TO: Chairwoman Nicole Love Hendrickson, Gwinnett County
ATTN TO: Catherine Long, Planning Manager, Gwinnett County
RE: Development of Regional Impact Review
FROM: Mike Alexander, Director, ARC Center for Livable Communities

Name of Proposal: Aventon Park DRI 3734

Description: A DRI review of a proposal to construct a mixed-use development consisting of 662 multifamily units with a clubhouse and amenities, 5,400 square feet of restaurant space, and 16,700 square feet of office/retail space on an approximately 58 acre site on US Highway 78 east of Rosebud Road in Gwinnett County. The currently mostly wooded site includes several wetland areas and a segment of Brushy Fork Creek.

REZONING SITE PLAN

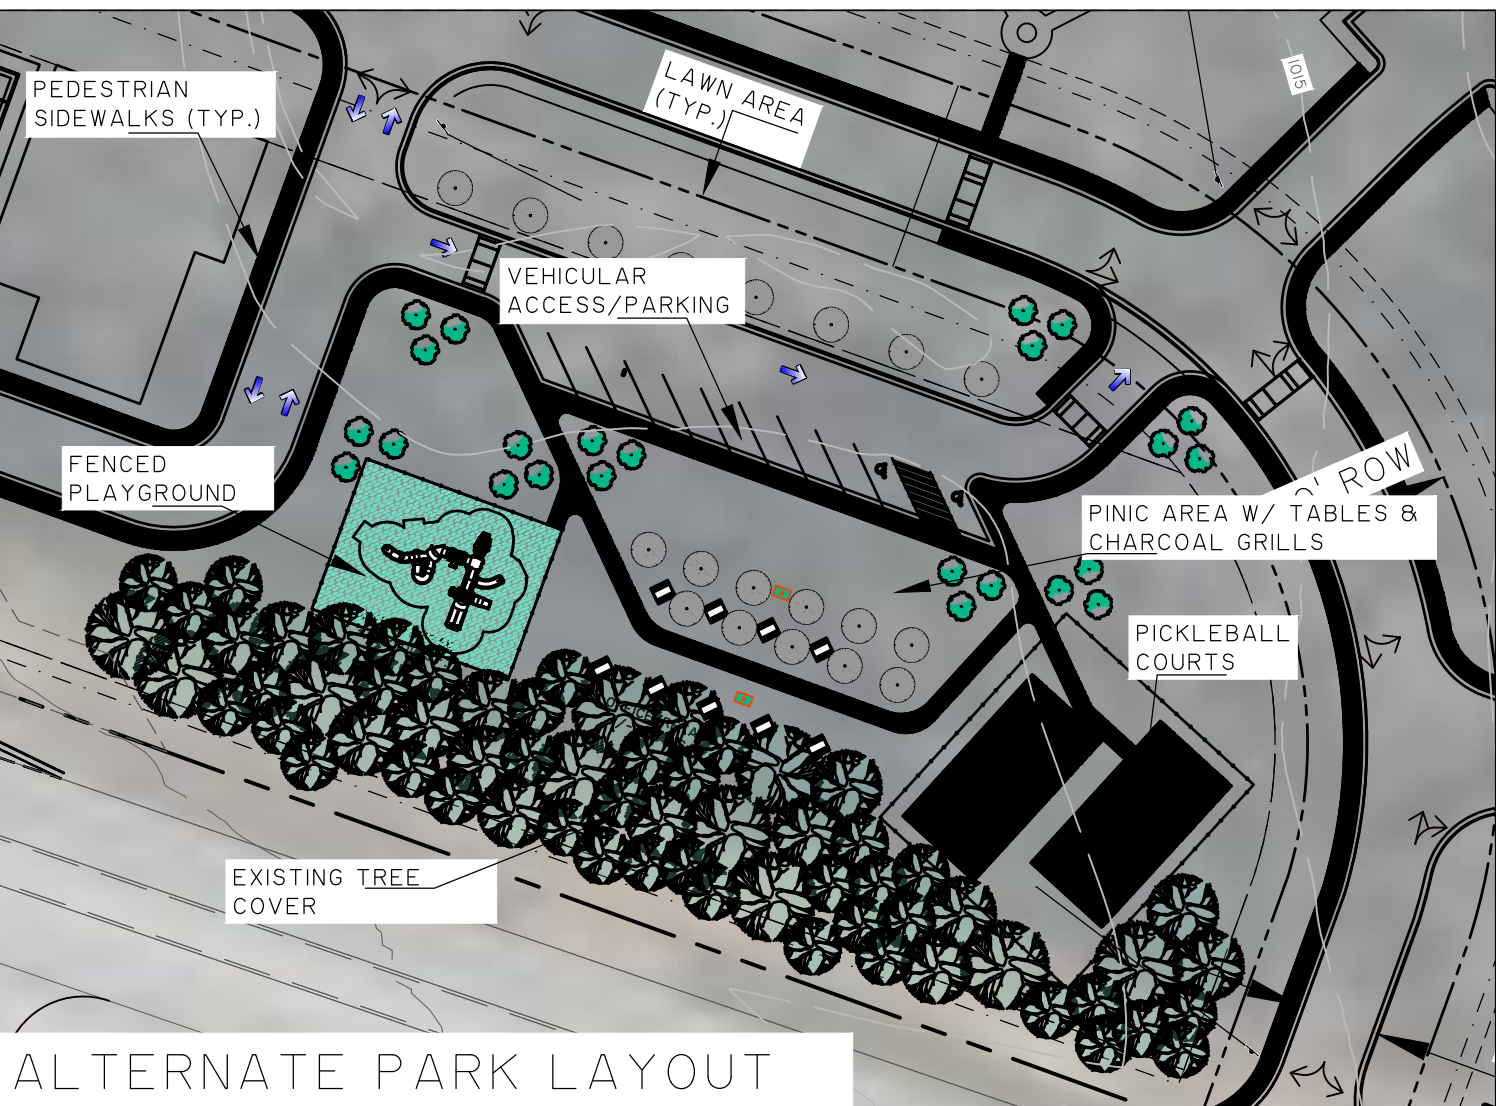
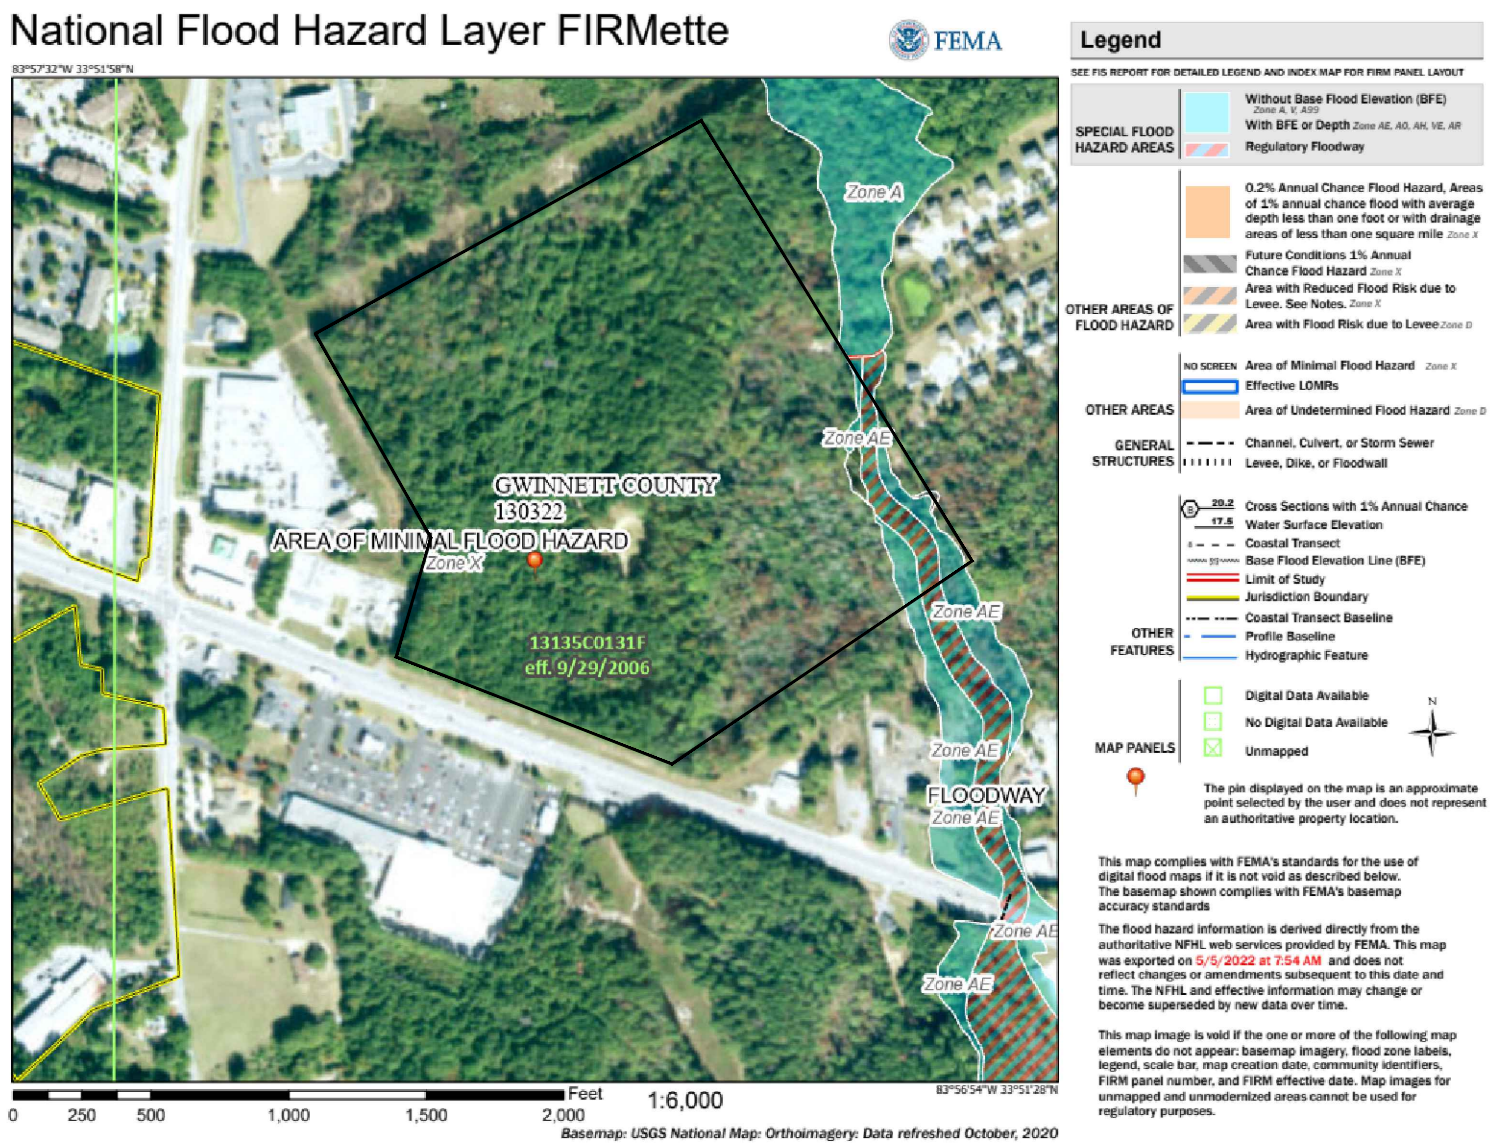
The mixed use aspect of the project is supportive of regional multi-modal transportation and placemaking policies. However, the residential elements of the project could be better integrated with the retail, office,

and restaurant uses though closer placement and the possible provision of a multi-use trail or other enhanced pedestrian connection linking the residential and other uses.

The site plan does not appear to show a sidewalk along the US Highway 78 frontage or a crosswalk connection across the highway to provide pedestrian access to the grocery store on the south side of the street. Provision of these basic pedestrian accommodations would be at least minimally supportive of regional walkability and multi-modal transportation requirements and policies.

Incorporation of green stormwater and heat island mitigation designs for the roughly 1,229 surface car parking spaces proposed would be supportive of regional environmental policies.
